Interactive comment on “Impact of LUCC on Streamflow using the SWAT Model over the Wei River Basin on the Loess Plateau of China” by Hong Wang and Fubao Sun

To: Hydrology and Earth System Sciences (HESS) Subject: Revise the manuscript (#hess-2016-332) The Authors: Wang & Sun The Title: Impact of LUCC on Streamflow Based on the SWAT Model over the Wei River Basin on the Loess Plateau of China Response: The authors appreciate Dr. Lacombe for helpful criticism and 8-pages constructive comments that improved our original manuscript. We have addressed the comments below and have made corrections. The changes being made are marked in red in the manuscript.

Fig. 1. Fig. 1 The development of soil and water conservation measures in the main stream basin of Wei River over last 50 years.

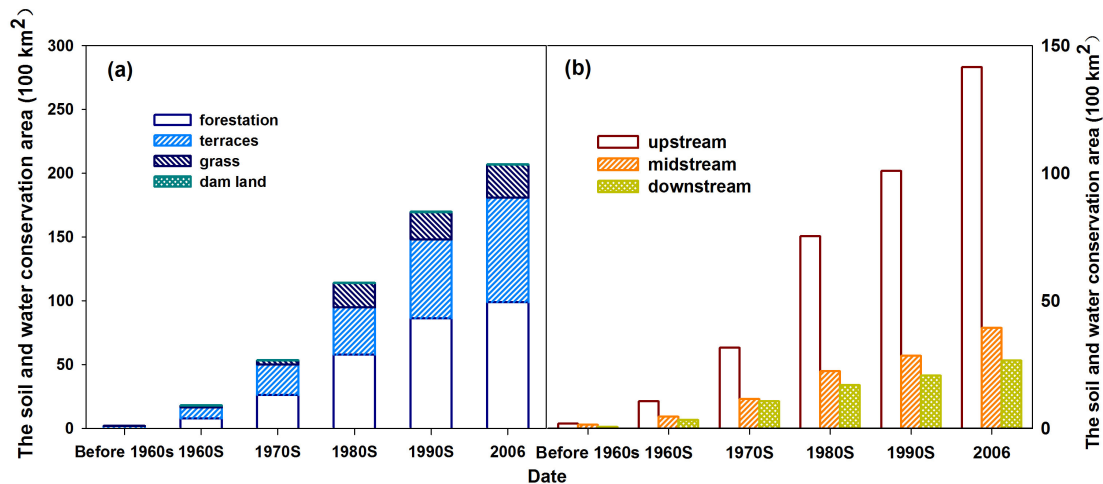
1: First of all, I am questioning the significance of the hydrological changes that actually occurred in the catchment over the studied period. Although figure 1 indicates that forested areas increased by about 65.104 hm² (unusual unit used on the Y axis), which is equivalent to 14% of the upper catchment area, figure 3 inconsistently shows that forested area increased by only 0.81% (line 137) over the same period (1980 to 2005). How to explain this difference? If we rely on figure 2 (which is likely the most reliable source), we can expect minor influence of forestation on the basin hydrology. Thank you for pointing this out, which makes us think it through. In fact, these two datasets are from different sources. First of all the number in Fig. 1 is for 6.53% (instead of 14%) as shown in detailed explanation below, which is still higher than 0.81% as pointed by the referee. This is a classic issue in the national survey on soil and water conservation where they only take the revegetation implemented into account and ignore for example possible death of vegetation, which is important in the land use map. One more thing is that the national survey when counting the revegetation areas does not consider the vegetation coverage, which is in fact important in any hydrological modelling including the SWAT modelling. We agree with the referee on that point. With that caution, however, Figure 1 is just for a reference on the development of the soil and water conservation project in China. The data we are relying on are the land use maps. Detailed explanation below:

(33) Lines 314-325. the authors explain differences in hydrological behaviour of the Loess Plateau and earth-rock mountain, based on other publications, but this paragraph is not linked to the result of the study. The authors need to evidence how these distinctive hydrological behaviours influence their results. Thank you for your suggestion. As suggested, we revised the whole manuscript carefully and add more details to make it clean. (34) Fig. 1: Areas under different treatments are expressed in 104 hm² (i.e. squared hectometers?). This is an atypical unit which is different from the unit used for the study area in the text (104 km²). All areas should be provided in same unit to allow easier comparison. It would be clearer to provide the percentage area so that we anticipate the possible effect of the land treatment on the catchment hydrology. Thank you for your suggestion. Figure 1 is revised as suggestion.

(1) There are some detailed descriptions about Fig.1. The same legends for Fig.1 (a) and (b) brought some confusion, so we revised the legends of Fig. 1. Figure 1 is the developing process of the soil and water conservation measures in the main stream basin of Wei River, including the upper and middle reaches (4.68×10^4 km²) and the downstream of the main stream (1.65×10^4 km²). Figure 1 involves about 6.33×10^4 km². Figure 1 (a) is the area developing of forestation, terraces, grass and dam land separately. The area of forestation was about 57.43×10^4 hm² during 1980s and it increased to 98.75×10^4 km² in 2006, which equivalent to 6.53% of the main stream basin of Wei River. And Fig. 1 (b) is the sum area of the forestation, terraces, grass and dam land in upstream, midstream and downstream. And the sum area increased

(2) Figure 1 is the statistical data of government based on natural forest before and artificial planting area, which involves all planting of forestation without considering canopy density, surviving or deforestation and so on. The forest of the LUC data refers to the natural forest and plantation, which canopy density is larger than 30% (Table 3: note 1).

(3) The forest data of Fig. 1 also includes planting land used as agro-fruit, agro-mulberry, agroforestry and replanting land for trees. While land used for agro-fruit, agro-mulberry, agroforestry is classed as Agricultural land (Table 3: note 2) in LUC.

(4) There are also some screening conditions for land use types dividing in SWAT model. For hydrological response unit (HRU) analyst, the Dominant Land Use method was used for HRU definition. So the dominant unique combination of land use in the subbasin is used to simulate the HRU. Figure 1 shows the area of grass is smaller than forest's, while it is opposite in LUC and SWAT model attributed to canopy density and the Dominant method.

Fig. 2. Fig. 8 The time-series graphs of calculated vs. observed streamflow during 1980-2009 for hydrological stations.

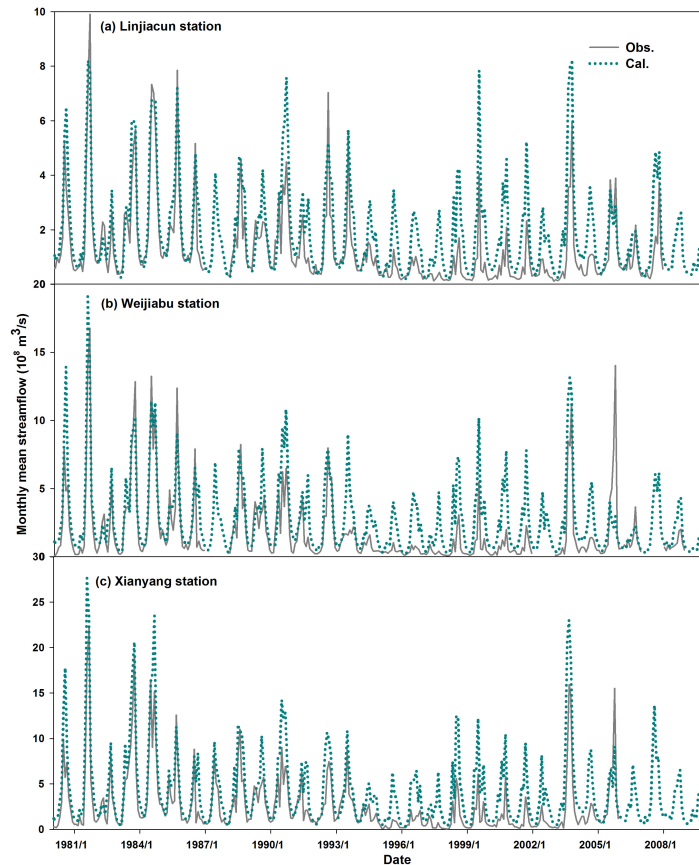
2.1 The main issue of this paper is that all the demonstration relies on simulated flows only. Flow simulated over the period 1980-2009 with land-use from 1980 should be compared to actual flow recorded over the period 1980-2009.

Thank you for your comments. We add a new Fig. 8 to show the time-series graph of calculated streamflow vs. observed streamflow during 1980-2009 for hydrological stations. We can see the calculated streamflow matched well with the observed values during 1980s. The observed values were measured daily based on the actual LUC, while the calculated streamflow was got based on LUC of 1980. So Fig. 8 shows the calibrated SWAT model played well in our study area and the changing LUC can

affect streamflow gradually. The streamflow of typical year, the same year with LUC, is the results of by LUC and meteorological conditions. To reduce influence of meteorological condition and isolate the impact of the LUC on streamflow, 30-year average of the streamflow for forest and agricultural land were taken, respectively. For period of 1980-2009, we just used their measured and long-term daily meteorological data in the study area to drive the validated model for the designed hydrological experiments.

Fig. 3. Fig.6 The time-series of precipitation, annual streamflow and runoff coefficients for the study area

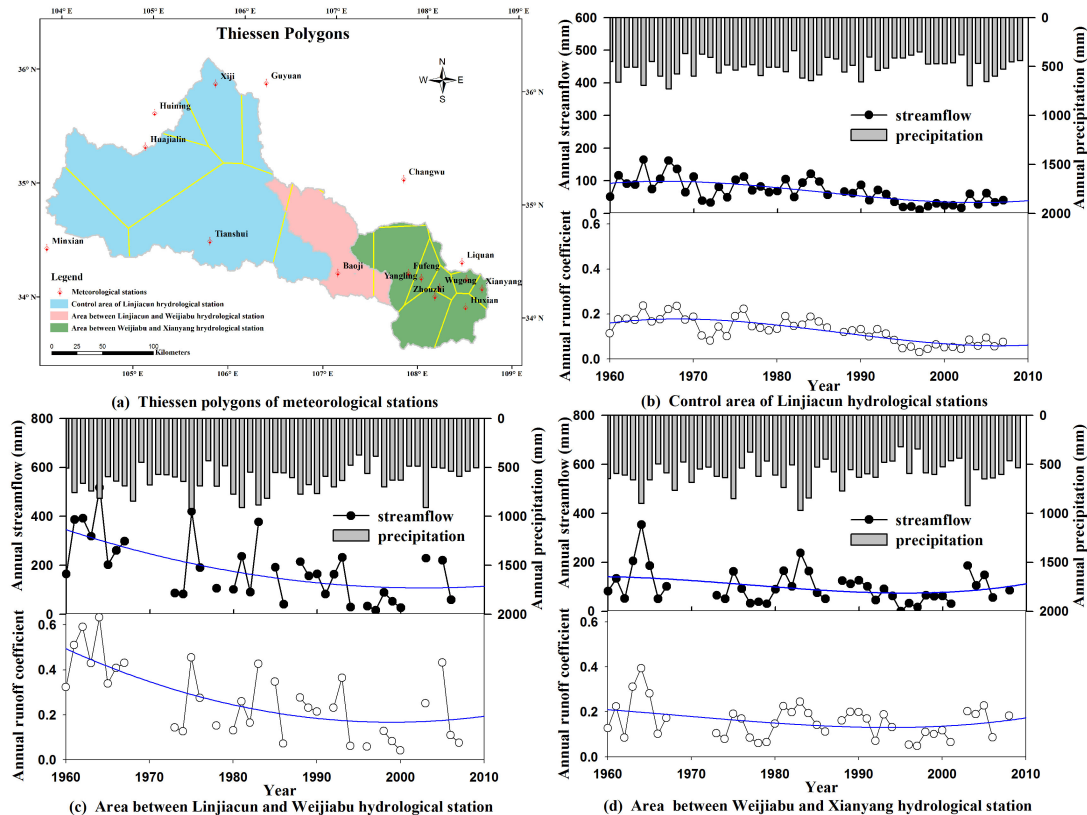
(2) Another issue is the implicitly presumed stability of the catchment behaviour over each of the 2 periods 1960-79 and 1980-2009. A graphic showing annual flow, rainfall (both in mm) and runoff coefficients in each of the 3 nested catchments and intermediary catchments (e.g. the colored areas in figure 2) would provide a first assessment of the possible effects of the land-use changes (as done in Lacombe et al. (2008)). A statistical assessment quantifying change and/or trend significance is also missing (cf. Lacombe et al. (2016) for an example).

(8) Line 90: This statement should be supported by a figure showing the time series of actual annual flow (cf. main comments).

Thank you for your comments. For period of 1980-2009, we just used their measured and long-term daily meteorological data of the study area to drive the validated model. There was only one variable (LUC or vegetation) to analyze its impacts on streamflow quantitatively. So the soil data, DEM and meteorological data are all same. The figures of annual flow, rainfall and runoff coefficients for 3 regions of Fig. 2 in the study area are added as Fig. 6. The annual average precipitation over the region was calculated using Thiessen polygon method of ArcGIS 9.3, which divided the basin and gave the weight of each meteorological station according to its control area (Fig. 6 (a)). And the regional annual average runoff coefficients were 0.13, 0.27 and 0.16 for figure 6 (a), (b) and (c) in turn.

Thank you for your suggestion. The figure of actual annual flow has been added (Fig.6).

Fig. 4. Fig. 1.1 The monthly time-series graphs of calculated vs. observed values during calibration period and verification period for hydrological stations

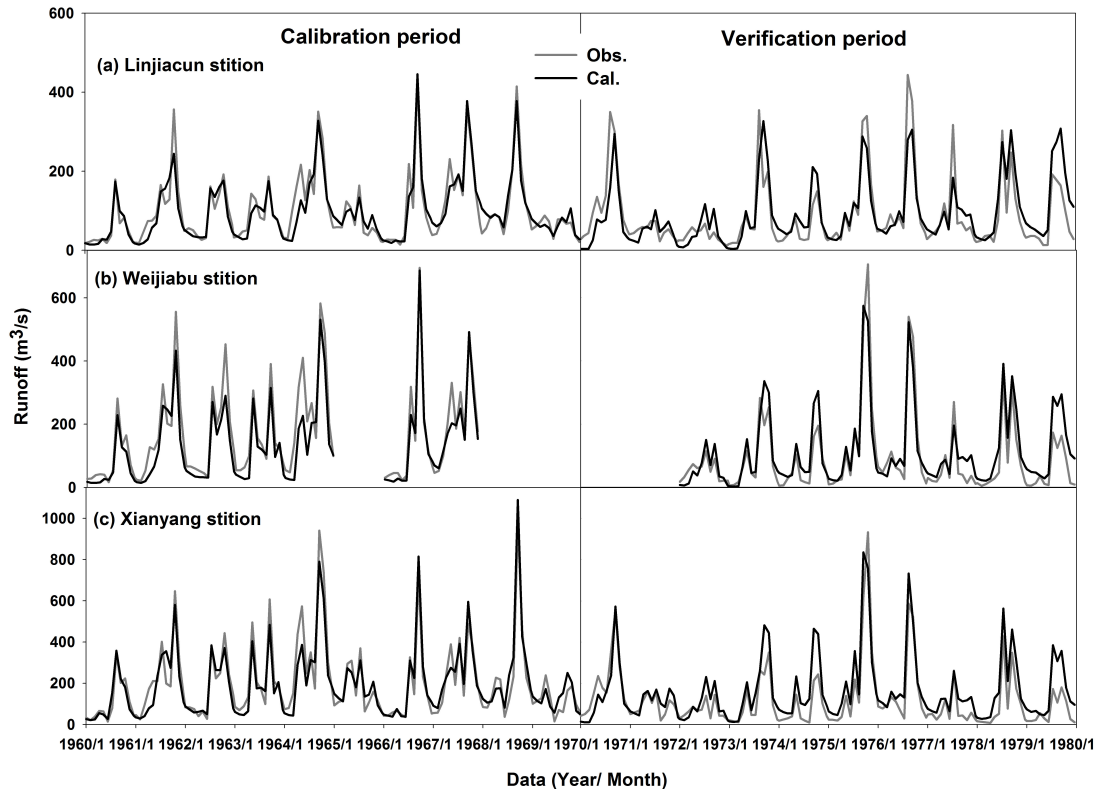
(27) Lines 257, 258: unlike what is written, the trend is not obvious in fig. 6. It would be clearer to redraw the figure at the monthly and annual time steps to visualize possible trends over years.

Thank you for your suggestion. The monthly time-series graph of calculated vs. observed values during calibration period and verification period for hydrological stations is as follows.

Fig. 5. Fig. 7 The time-series graphs of calculated vs. observed values during calibration period and verification period for hydrological stations.

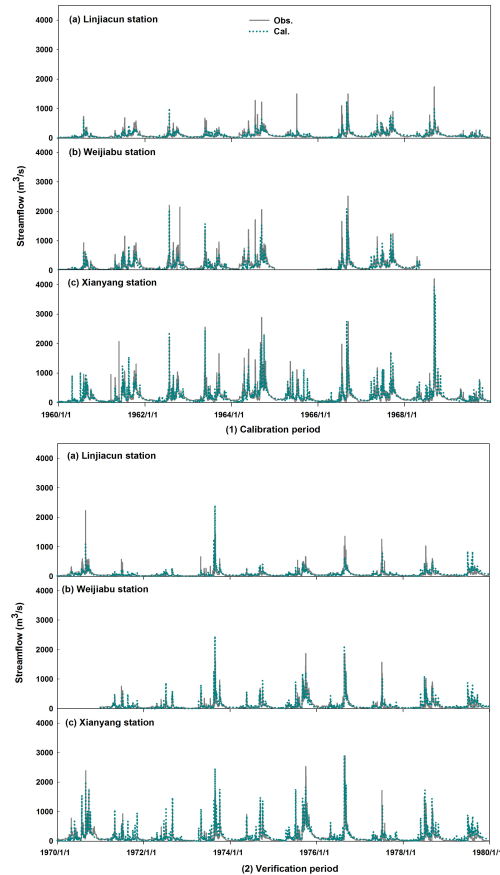
(36) Fig. 6. The scale on the X axis is too big: we cannot see the details in the daily flow variations and in the matching between observed and simulated flow. The figure should be bigger or all panels (calibration and verification should be put in the same column to allow larger size.

Thank you for your suggestion. It is more clearly indeed as suggestion (Fig. 7).

Fig. 6. Fig. 11 The corresponding proportional change rate of streamflow at Linjiacun, Weijiabu and Xianyang station for annual average and annual average in non-flood season.

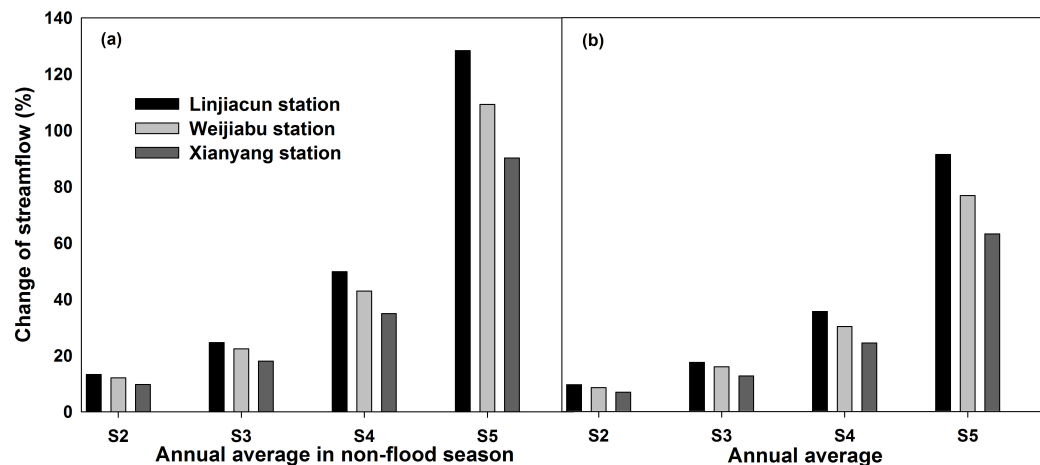
(37) Fig. 9: What is the meaning of “corresponding proportional change rate”? Thank you for your suggestion. It is the change rate of streamflow at the Linjiacun, Weiijiabu and Xianyang stations correspondingly. We have revised the figure (Fig.11).
